SUBJECT: OPERABILITY DETERMINATION FOR THE CALLAWAY PLANT
TECHNICAL SPECIFICATIONS REQUIREMENTS WHEN ONE MAIN
STEAM ISOLATION VALVE ACTUATOR TRAIN IS REMOVED FROM
SERVICE

OPERABILITY DETERMINATION FOR CALLAWAY MAIN STEAM ISOLATION VALVE (MSIV)

Operability Evaluation of Callaway MSIV Actuators

Figure 4
MSL Break
Single Failure of SI Inst Train
With Train B Actuator Removed From Service
MSIV Fails to Close

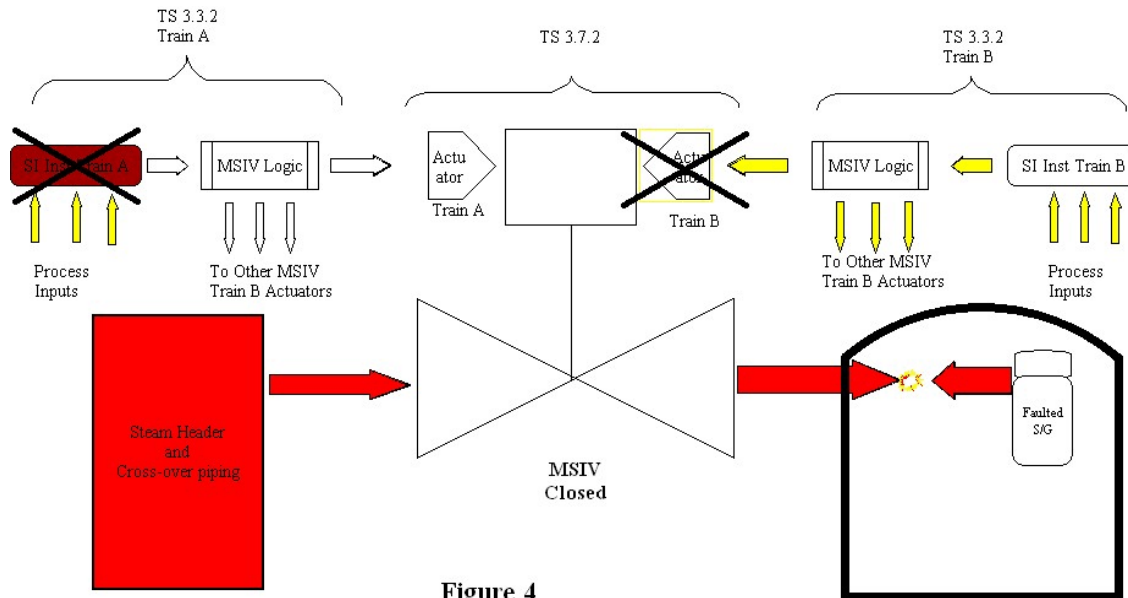
Figure 4 illustrates the system response with the Train B actuator removed from service with the single failure of the Train A SI Instrument Logic. The MSIV, with the actuator removed from service, fails to close.

Figure 5
MSIV MSL Case
With One Inop Actuator

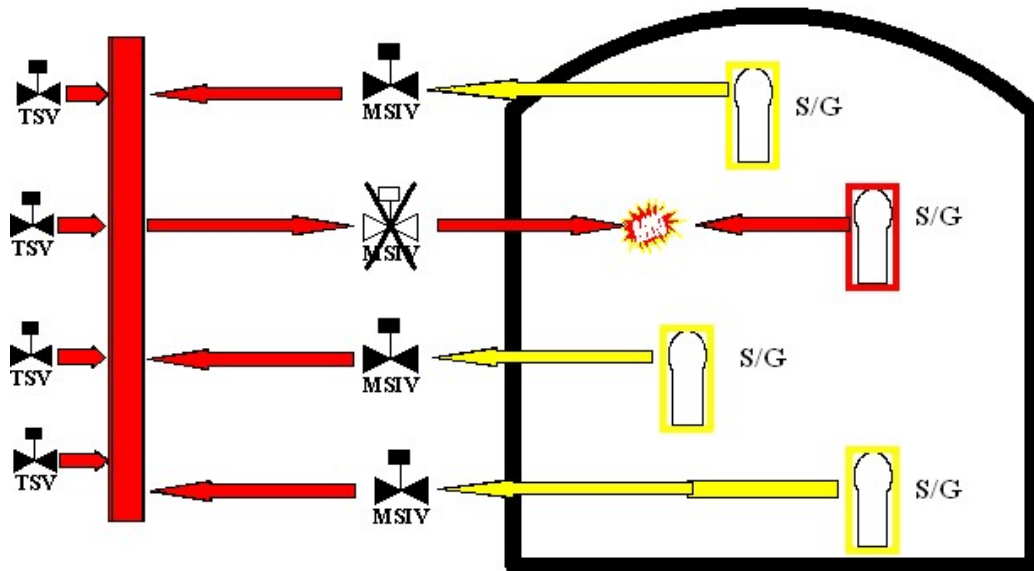
Figure 5 illustrates the affect of the failed MSIV on the post accident containment response. Additional enthalpy from the MSL cross over piping steam is added to containment as result of the MSIV to close. The resulting peak postulated containment pressure and temperature exceed the bounding DBA analysis case. The licensee proposed adding this new accident case to the licensing bases but concluded prior NRC approval was required.

RIS Section 2.1.b states that SSCs that are not explicitly required to be operable by TS, but perform required support functions (as specified by the TS definition of operability), are also required to be operable by TS. The actuators, a sub component of the MSIV, fall into this category. The MSIV safety function, with the assumed single failure of an SI instrument train, cannot be accomplished without both MSIV actuators available. The MSIV TS out of service time must be applied if an actuator is not capable of performing the intended function.

Figure 6
MSIV MSL Case
With One Inop Actuator Train
Removed From Each MSIV
Uncontrolled Blowdown of All S/G

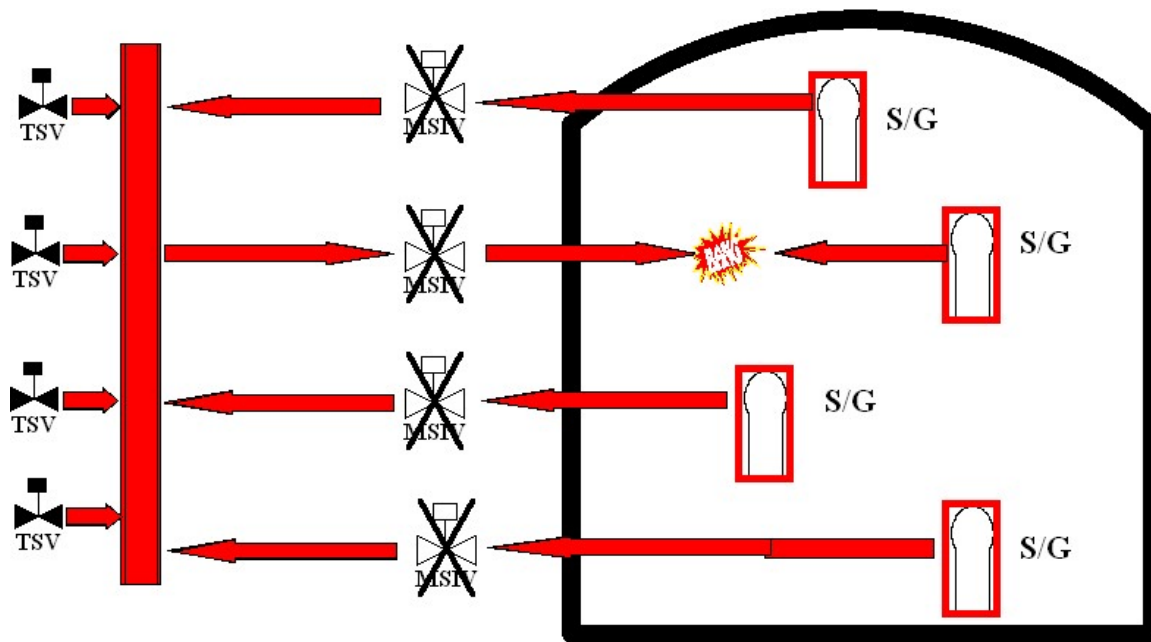
Severe accident consequences (in excess of Part 100 Guidelines) are possible if the operability MSIV actuators are not control under TS. For example, at Wolf Creek the licensee assumes only one actuator is required for MSIV TS operability. Under this assumption, the licensee would be permitted to remove one valve actuator from service on each MSIV without applying the TS out of service time. An uncontrolled blow down of all steam generators is possible if the MSL break DBA occurs under these conditions (with the single failure of the SI instrument Train A, shown in Figure 6). The blowdown of more than one steam generator would result in containment.

pressure much greater than the design value of 60 psig, directly challenging the fission product barrier. The uncontrolled blowdown of all steam generators qualifies as a severe accident. The resulting rapid reactor coolant system cool down and depressurization would also indirectly challenge the fuel clad by a return to power (local peaking) and the depart from nucleate boiling. 10 CFR 50.36(c) (ii) (C), Criterion 3, requires TS for SSC that are part of the primary success path and which function or actuate to mitigate a DBA or transient that either assumes the failure of or presents a challenge to the integrity of a fission product barrier. The MSIVs fall into this category. Both actuators on each MSIV are also required to be functional for the MSIV to perform the safety functions described in the accident analysis. Both actuators must be functional for the MSIV to be operable under TS 3.7.2.
